PRODUCT / PROCESS CHANGE NOTIFICATION

1.1 Company	 STMicroelectronics International N.V
1.2 PCN No.	MICROCONTROLLERS/24/14864
1.3 Title of PCN	ST Crolles (France) additional source for STM32G05x/7X/8x and STM32G0Bx/Cx products in 90nm technology.
1.4 Product Category	STM32G05x, STM32G07X, STM32G08x, STM32G0Bx, STM32G0Cx
1.5 Issue date	2024-07-15

PCN14864 – Additional Information

ST Crolles (France) additional source for STM32G05x/7X/8x and STM32G0Bx/Cx products in 90nm technology.

Example on package UFQFPN 7X7X0.55 48L as below:

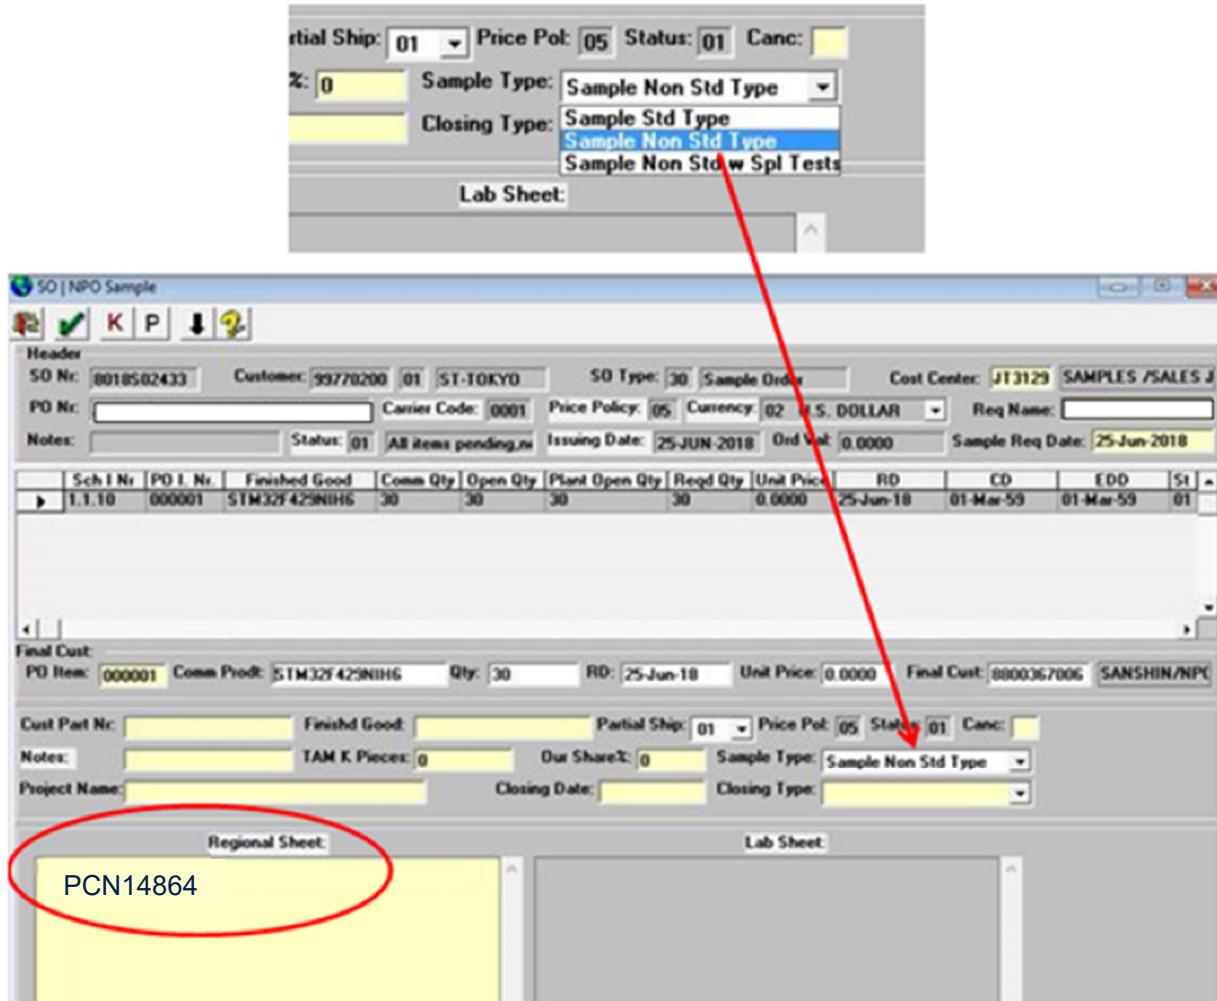
- **R - Die Revision changes**
 - Die 460 from **Y** (TSMC FAB14) to **1** (ST Crolles 300)
 - Die 467 from **Z** (TSMC FAB14) to **1** (ST Crolles 300)
- **WX - Diffusion traceability plant code** transferred from **9R** (TSMC FAB14) to **VQ** (ST Crolles 300)

Current condition	New condition
Front-End Diffusion site	TSMC (Taiwan)	ST Crolles 300 (France)
STM32G05x/7X/8x Die revision Marking R	Die 460 Cut 2.1	
	“Y”	“1”
STM32G0Bx/Cx Die revision Marking R	Die 467 Cut 1.1	
	“Z”	“1”
Diffusion traceability plant code WX	“9R”	“VQ”
